# SKYLINE AT LORSON RANCH

EL PASO COUNTY, CO  
**PLANNED UNIT DEVELOPMENT AND  
 PRELIMINARY PLAN**

# PUDSP V\_1 Planning Redlines Only.pdf Markup Summary 3-10-2021

**DT01**  
 SHEET 02 OF 07  
 PCD FILE NO.:

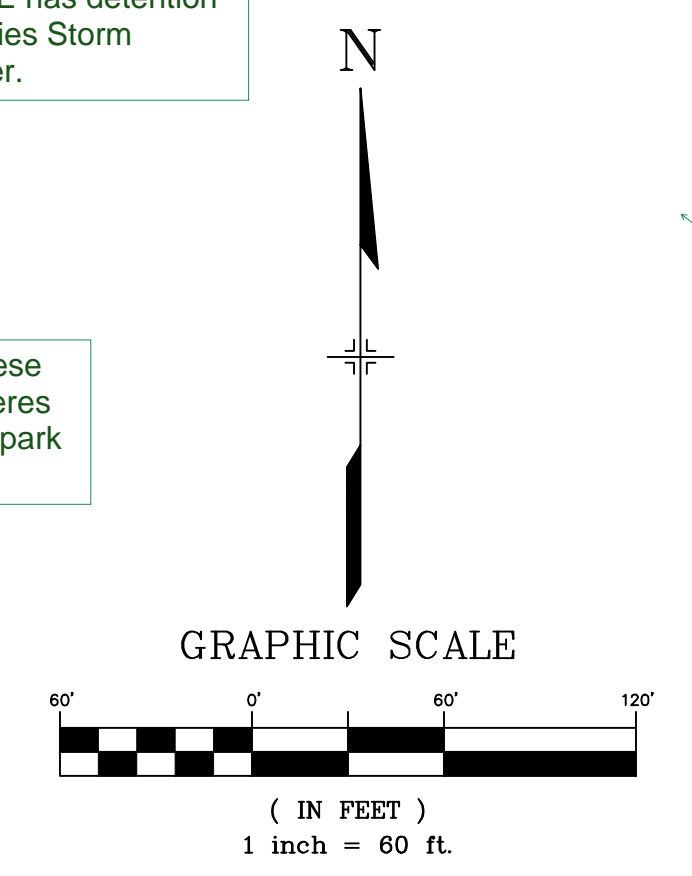
tract H is the POWERLINE EASMENT- very limited uses no public improvements allowed...I think a trail was allowed, I dont think detention was?

How is this openspace? It needs to be removed from the open space count as its not ...

A,B,C are really landscape correct? Is there drainage and Utilities?

remove from Tracts E and D

remove park- these are not parks theres only one pocket park provided

Show TRAIL

No detention pond is proposed except for tract E has detention facilities Storm Sewer.

Do additional tract or add to lot 42

DT02

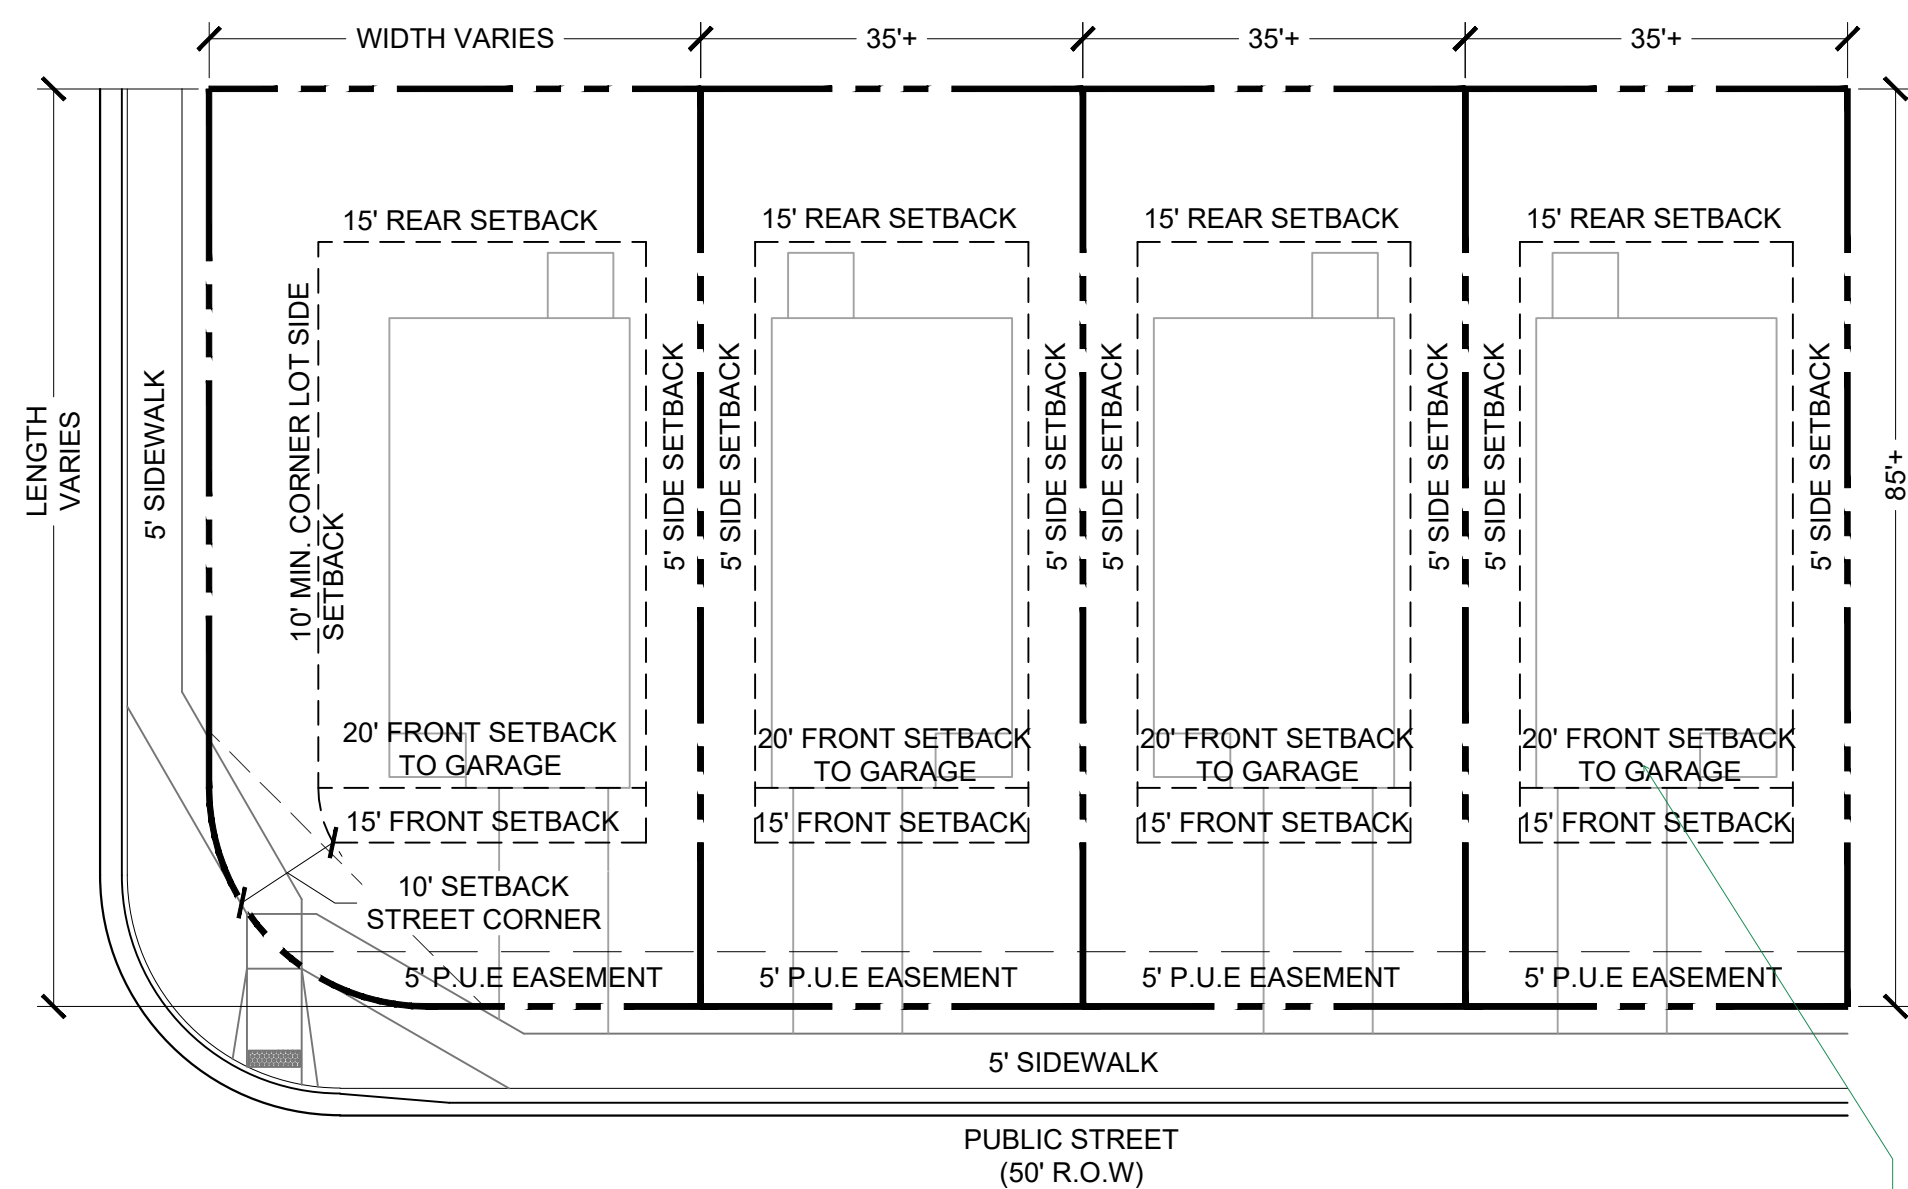
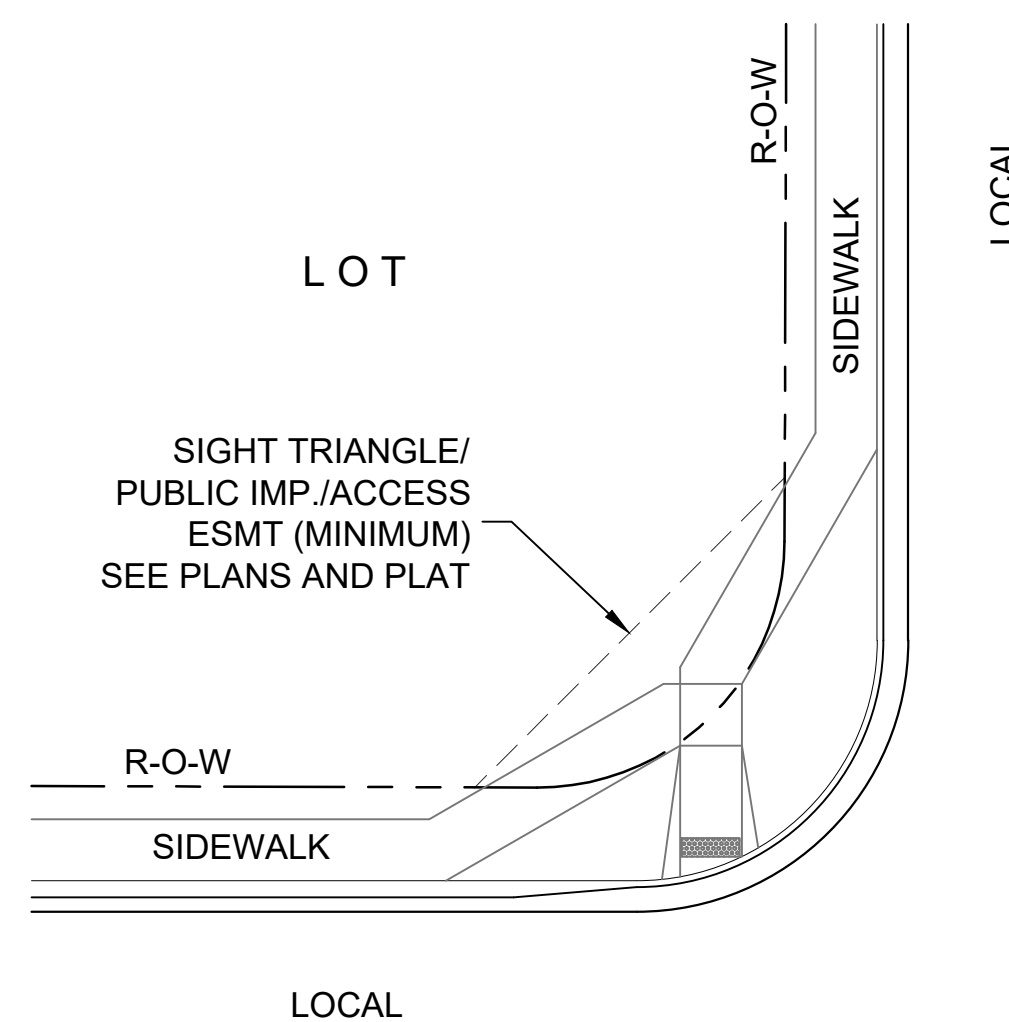
So the garage is behind the house?

what about attached pergolas and decks...will they really fit outside of the 15-foot setback?

Identify the specifics for the tracts that will be built on; provide the setbacks, uses, height, max coverage for the tracts... and show LS & parking, driveway access, standards, where is the access to the pump station tract?

TYPICAL SECTION 50' R.O.W.  
 RESIDENTIAL URBAN LOCAL  
 NOT TO SCALE

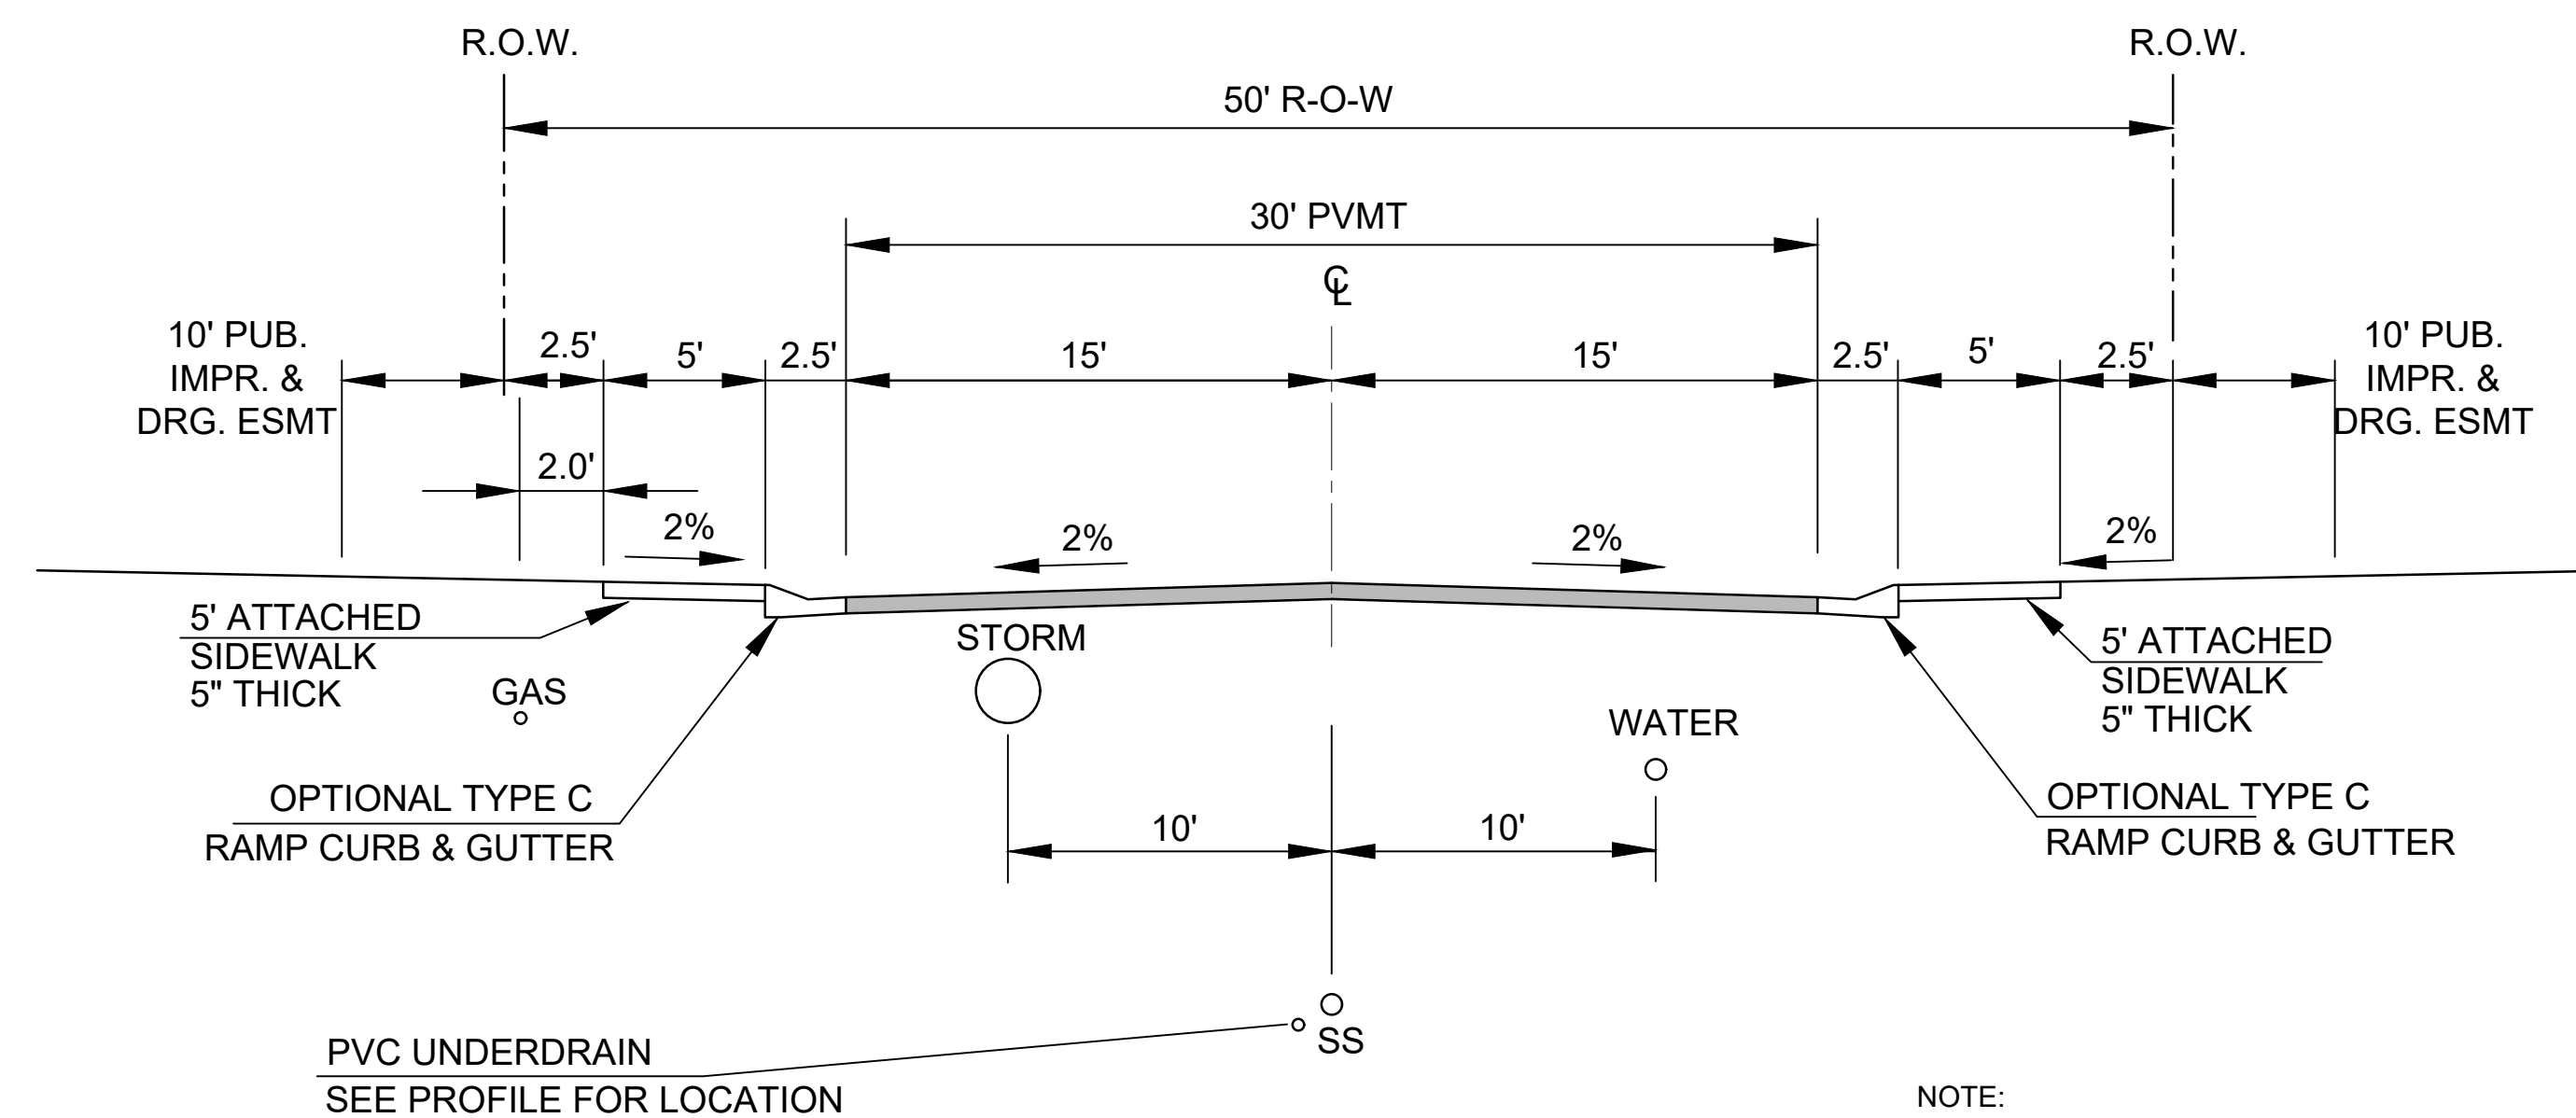
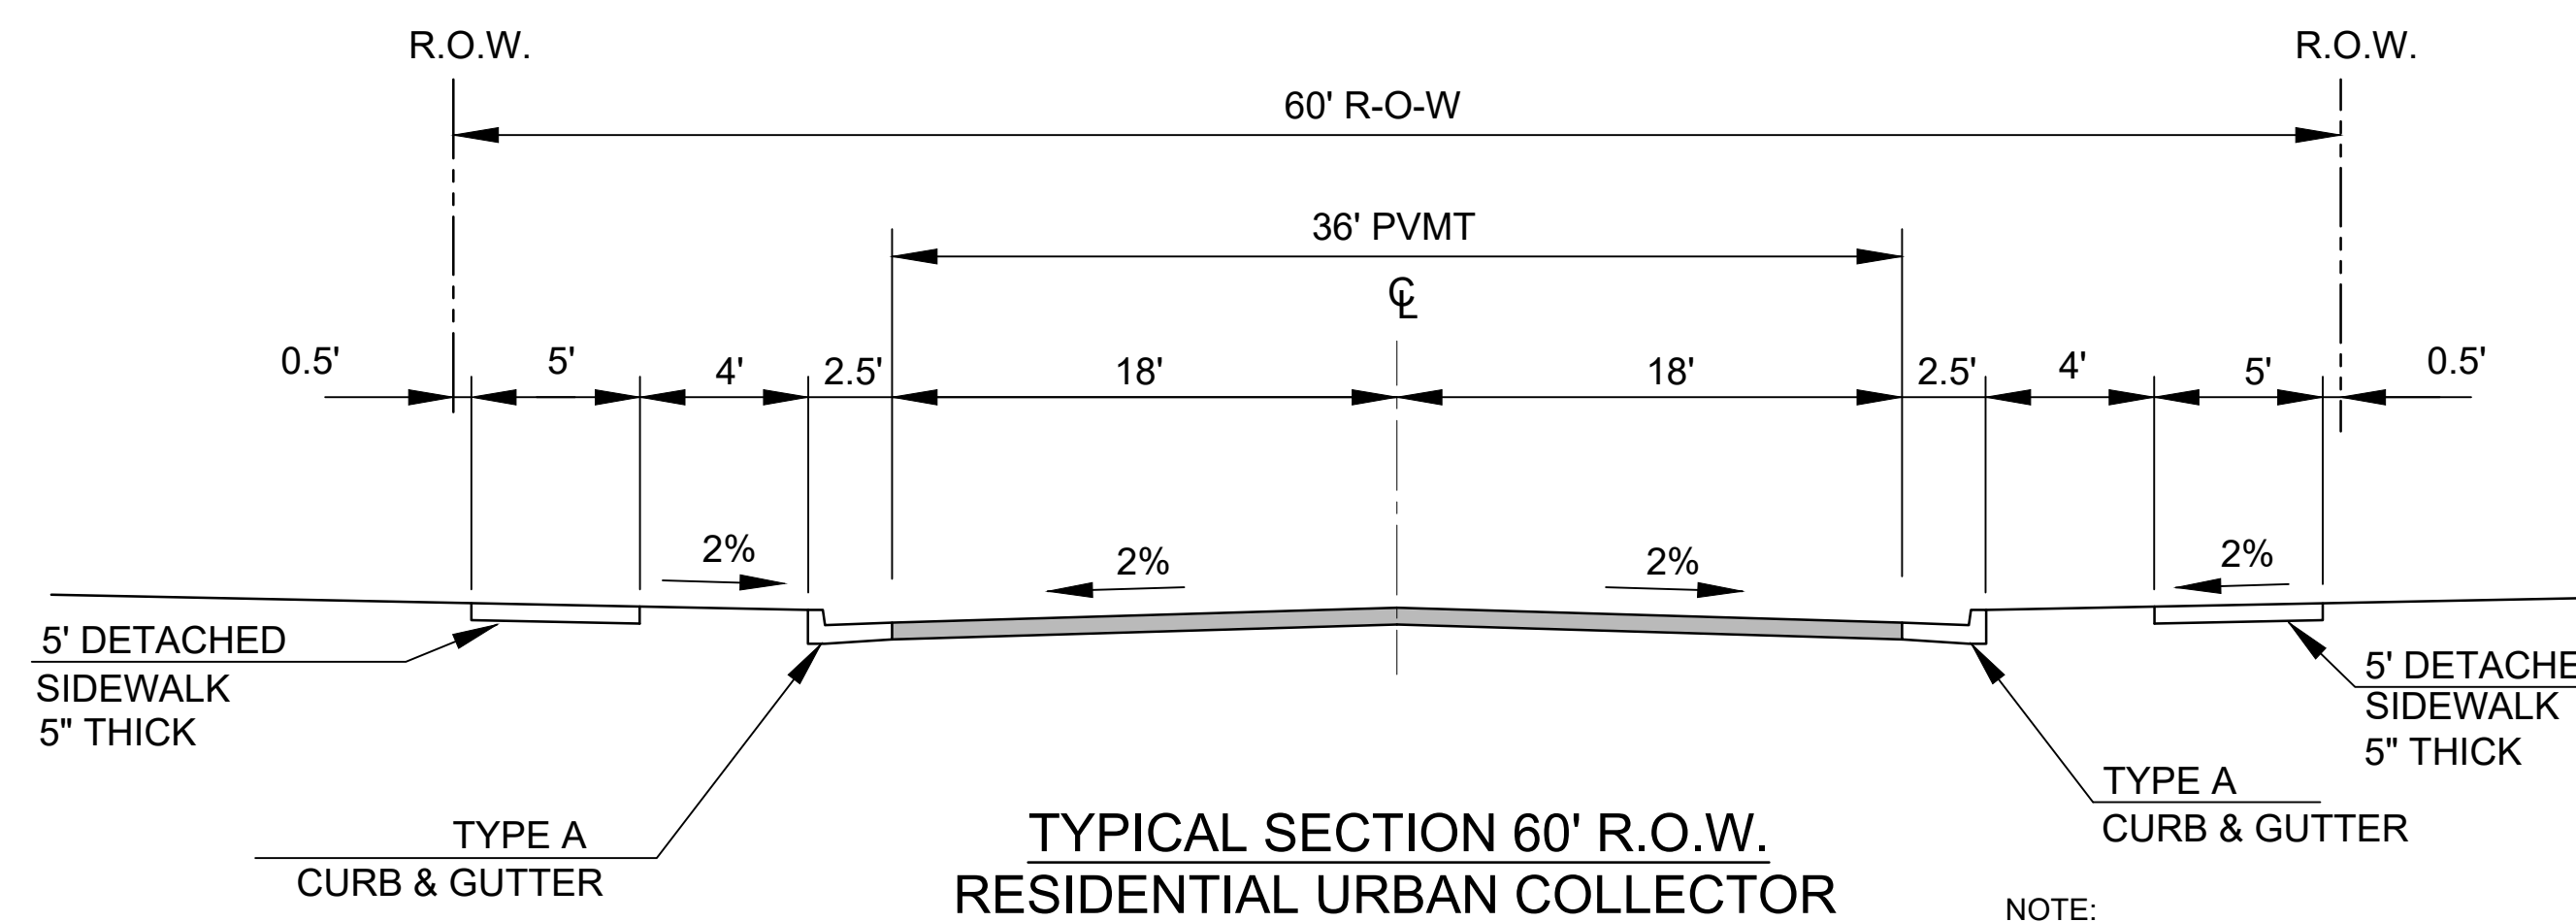
you have these details later in the set; you dont need to show twice...deleting here may allow to add notes here instead of sheet 3...
